# **A G E N D A**

## **Architectural Review Board**

**July 28, 2015**

418 Thorn Place

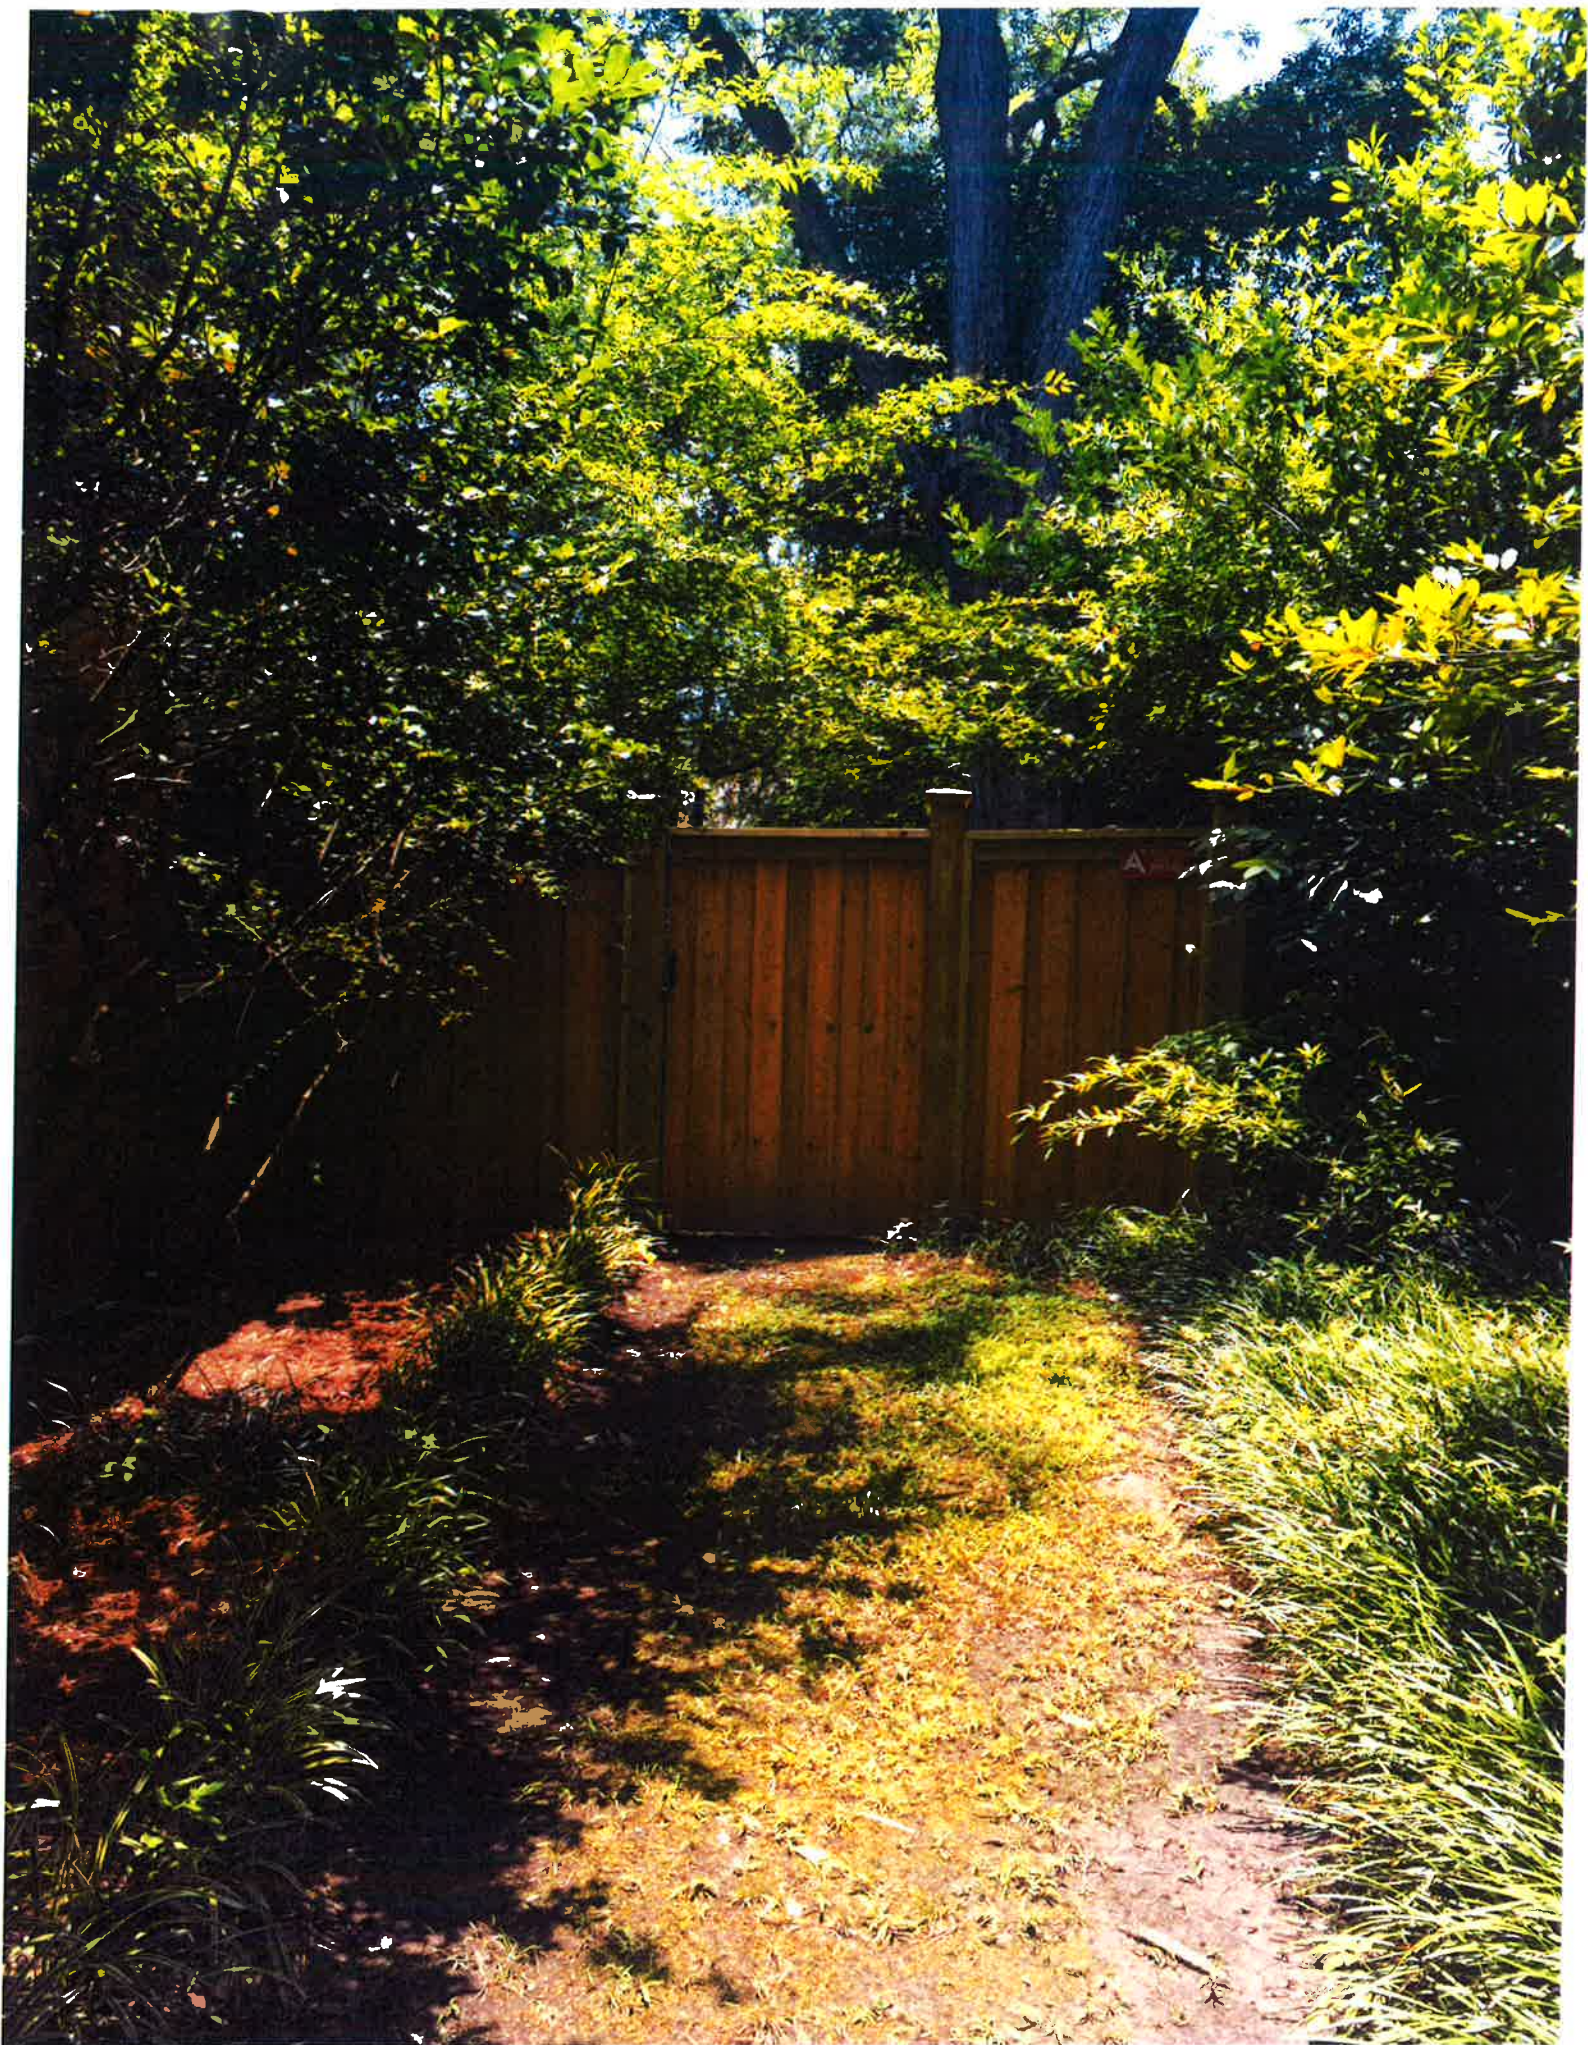
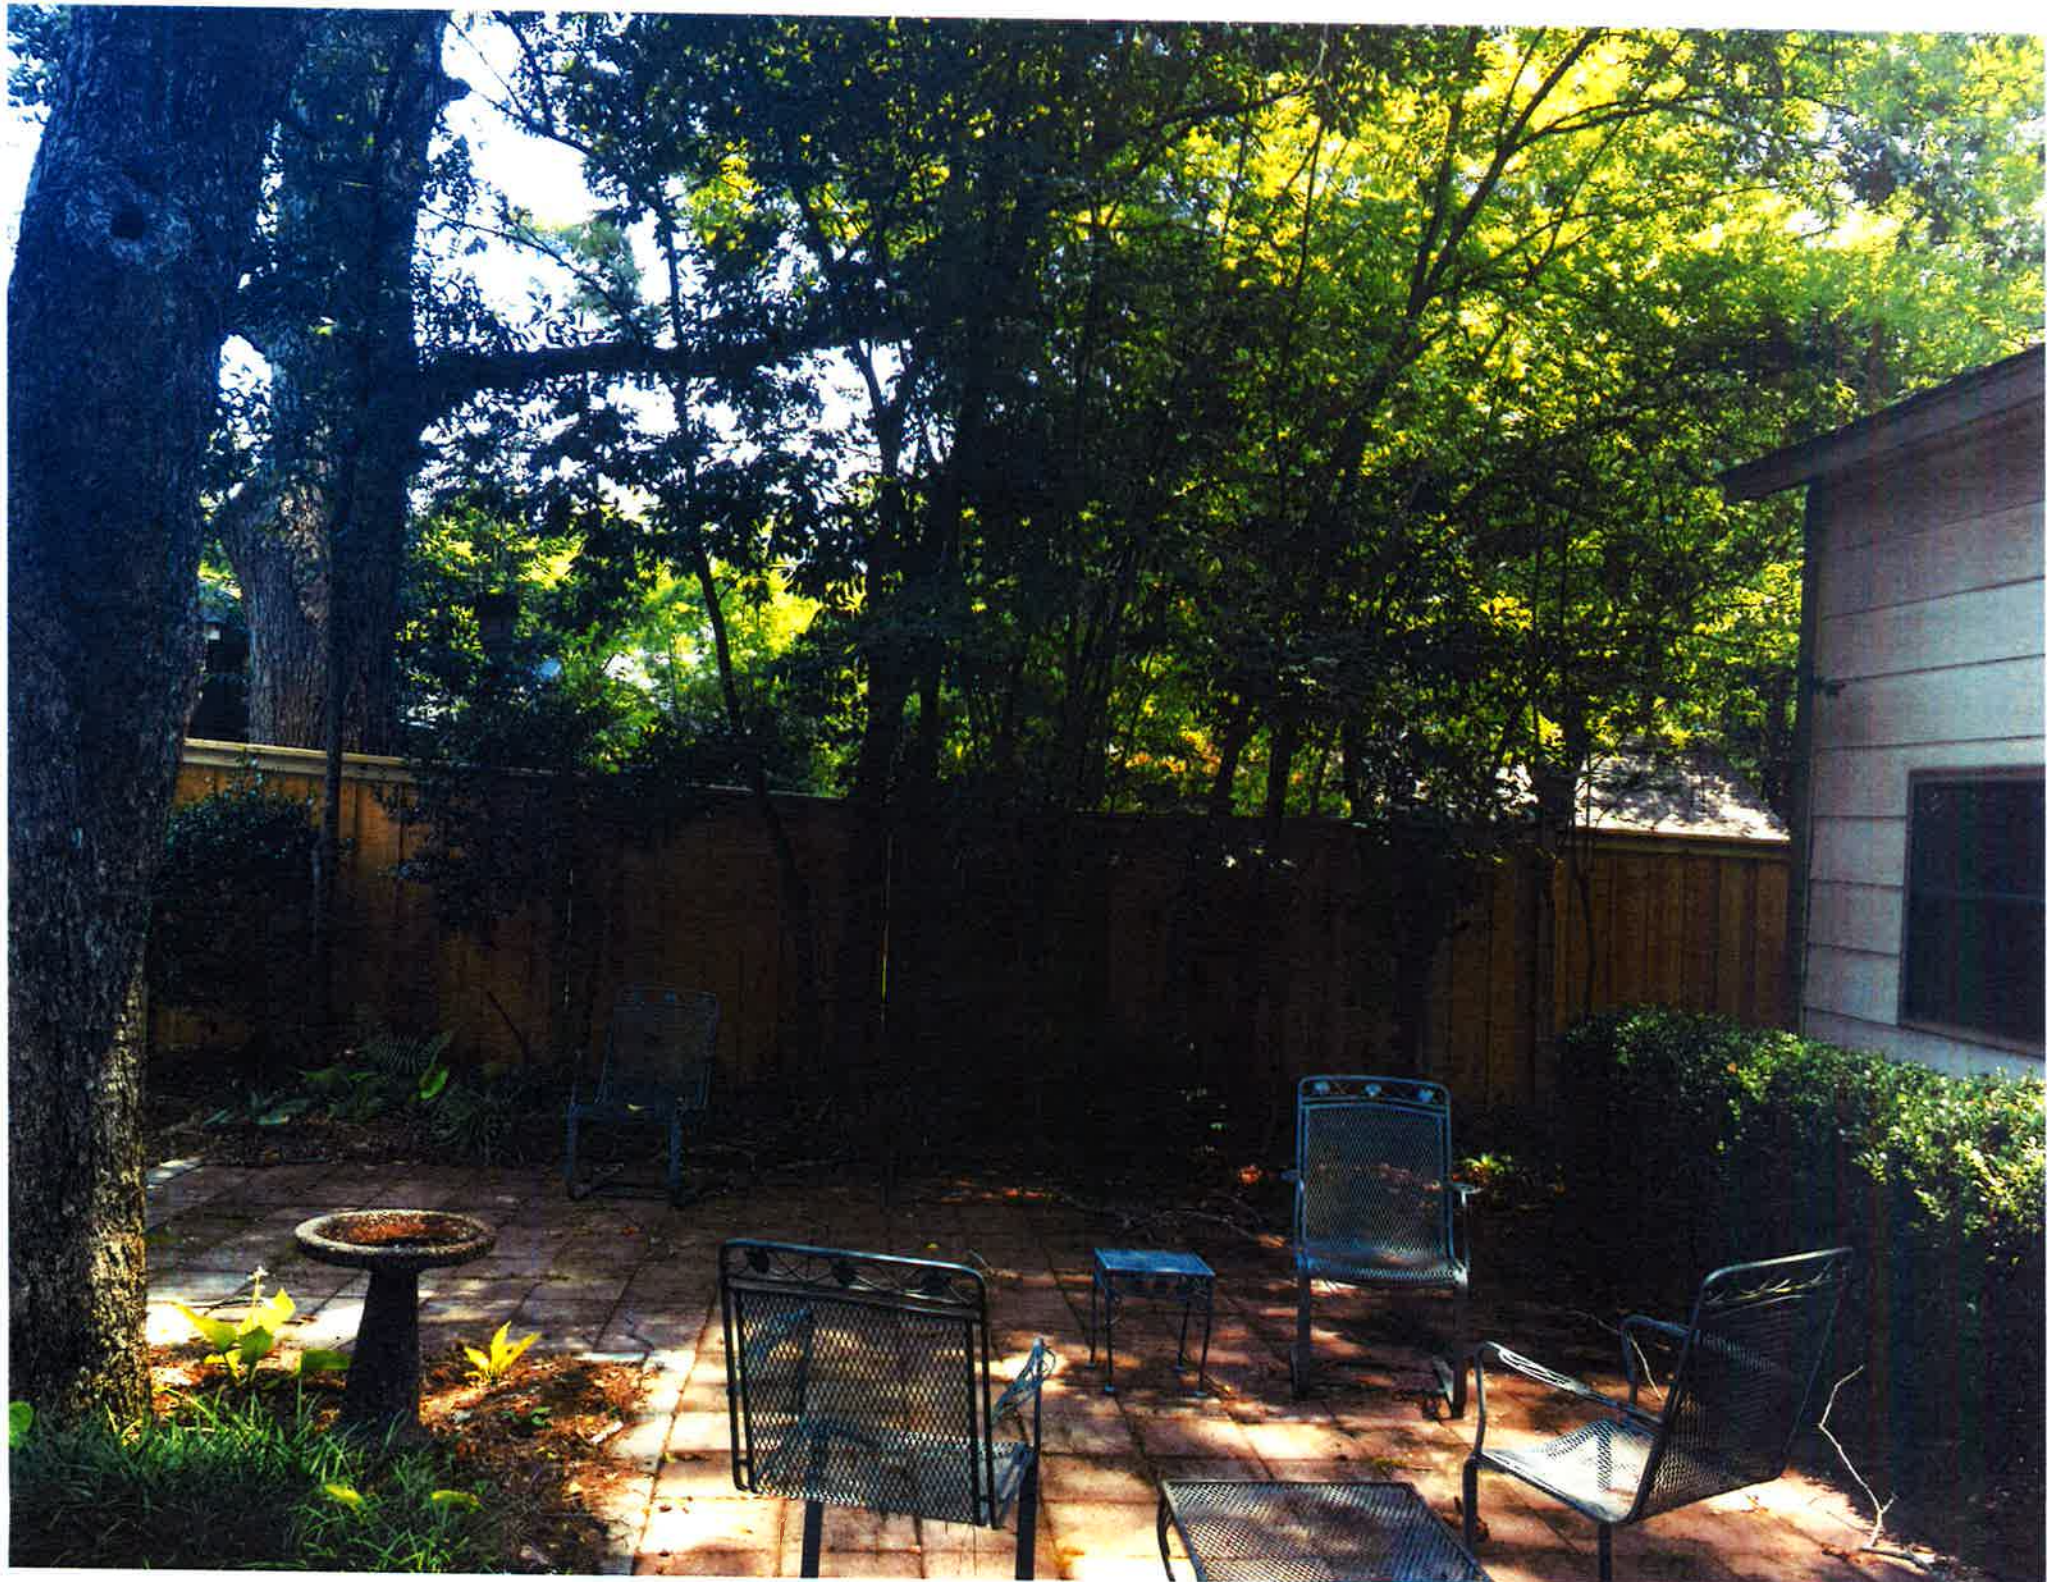
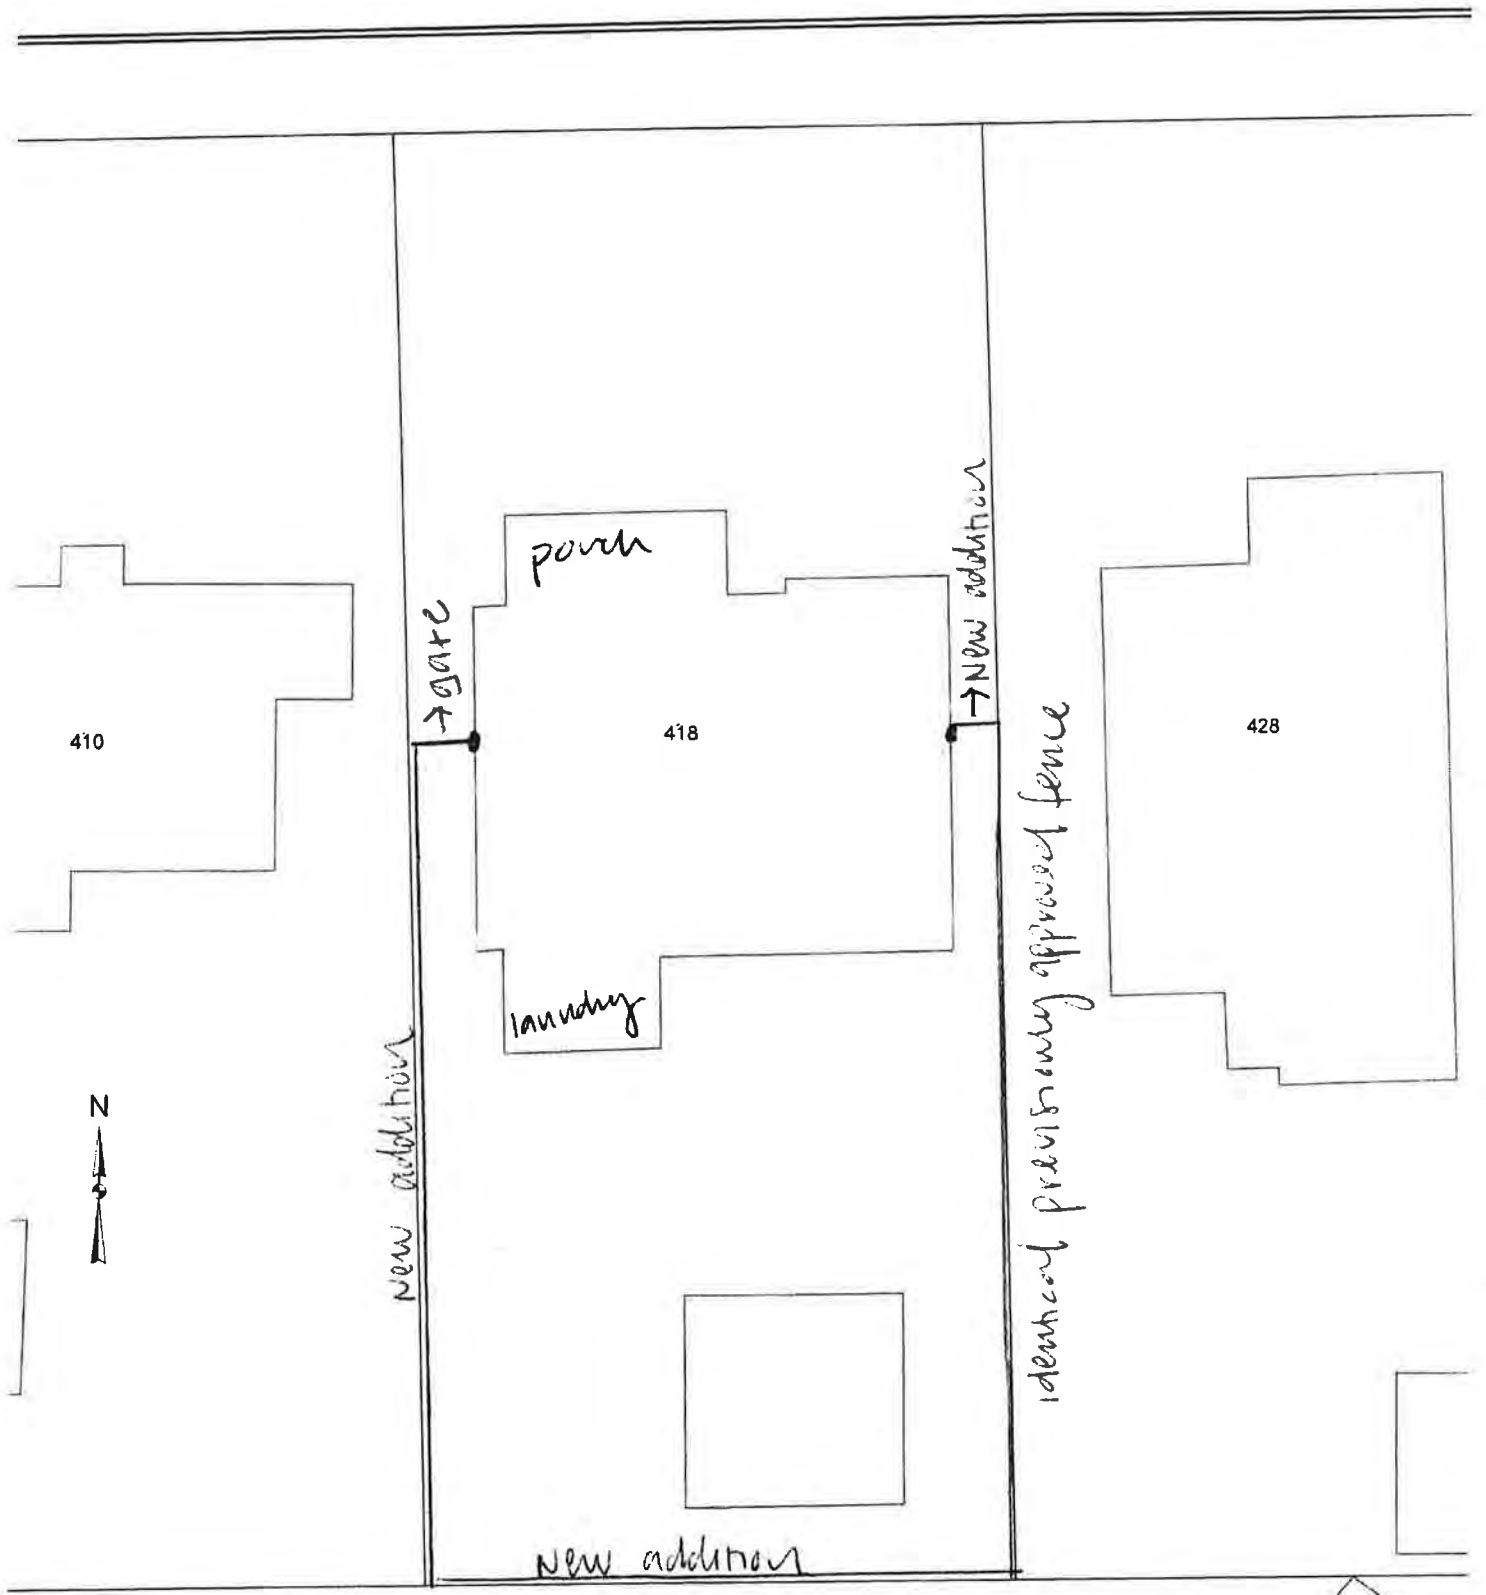
- One of the primary concerns with privacy fences is where the fence returns to the house (the closer to the rear the better). As submitted, the fence return will be behind the front corner of the house.

2046 Ridge Avenue - detail of proposed driveway

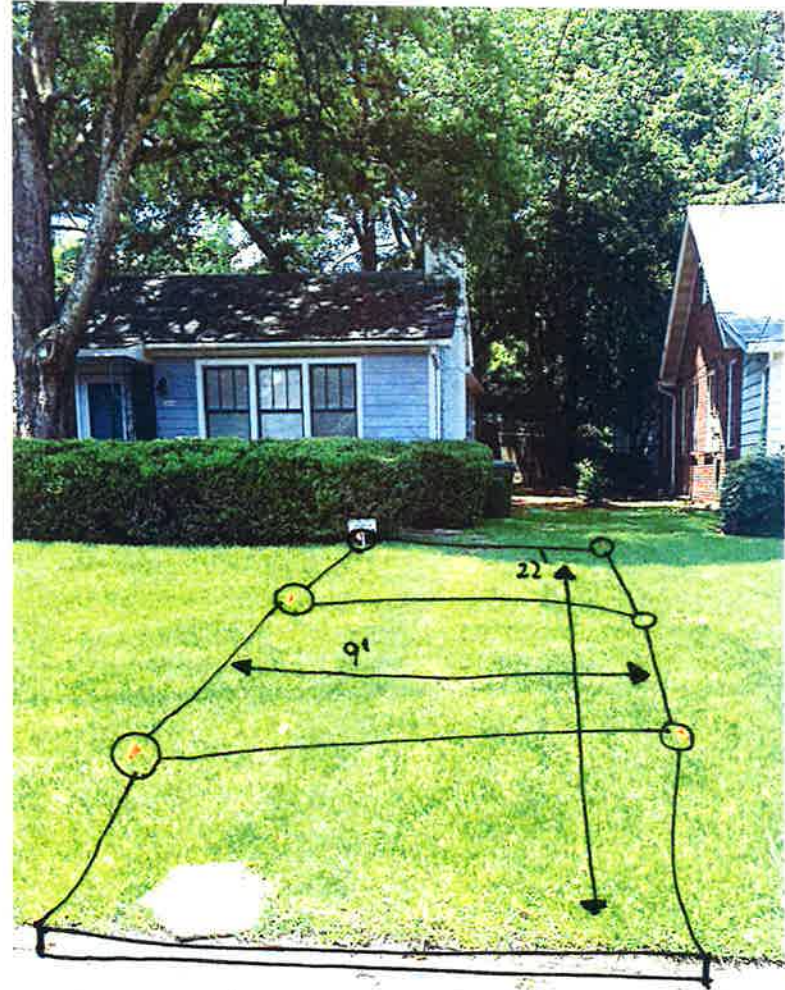
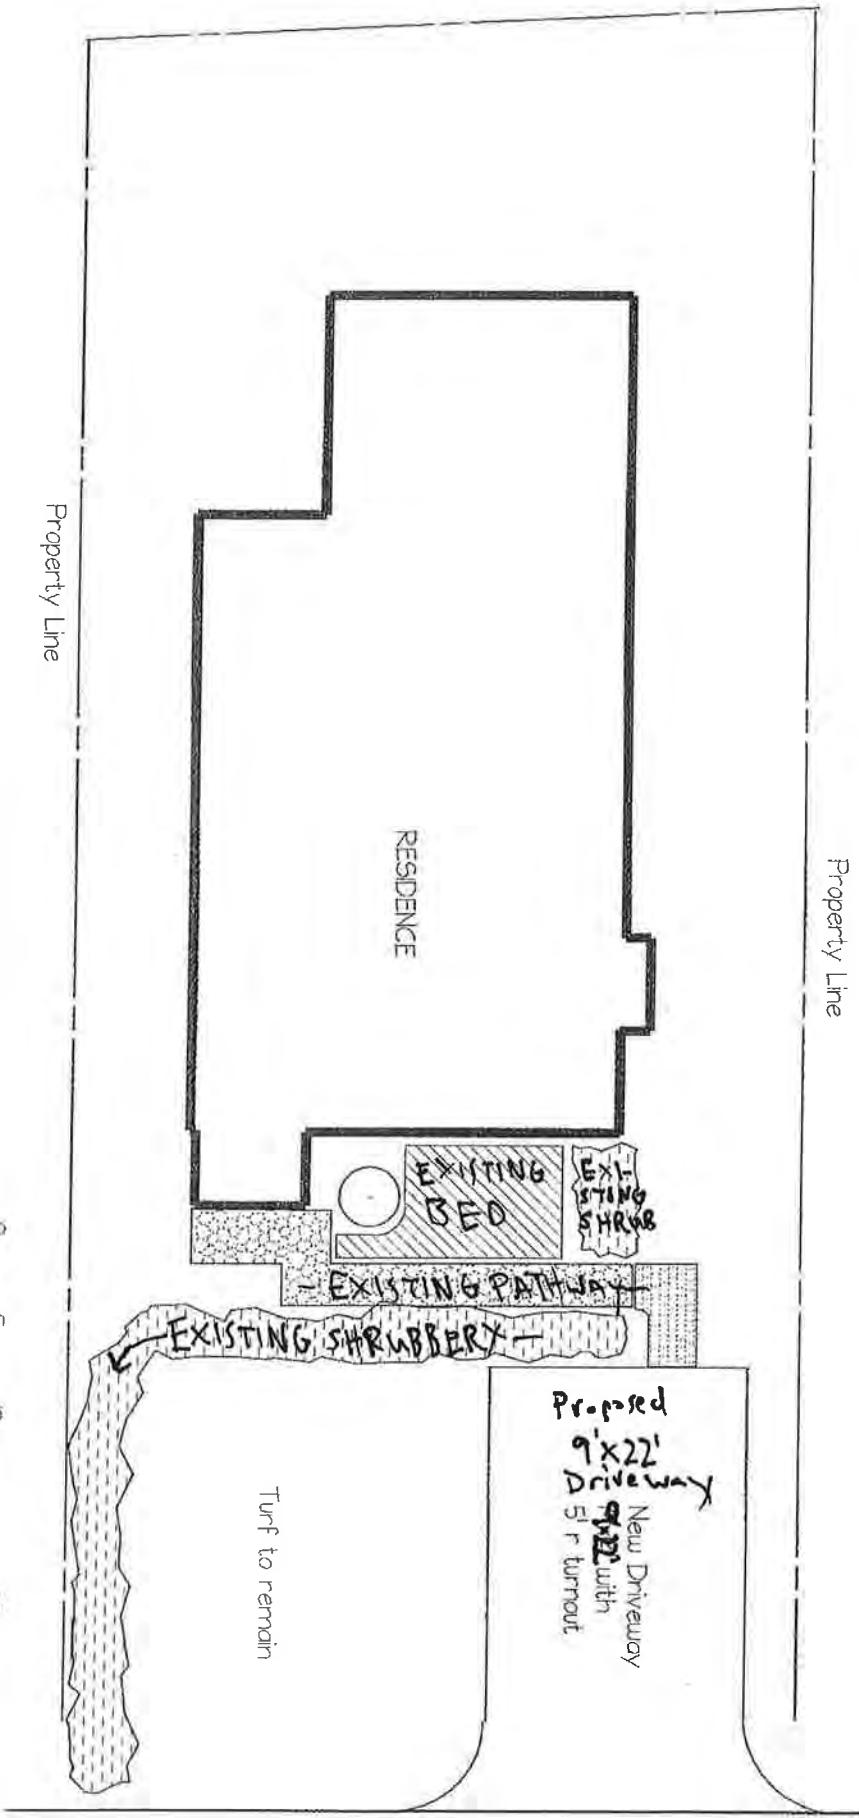
- The property was carved out of a larger parcel (see attached map) which limits the options for off street parking. The proposal retains well over 50% of grass/vegetation in the front yard.
- If a concrete apron at the street is not proposed, some sort of gravel containment at the street is recommended.
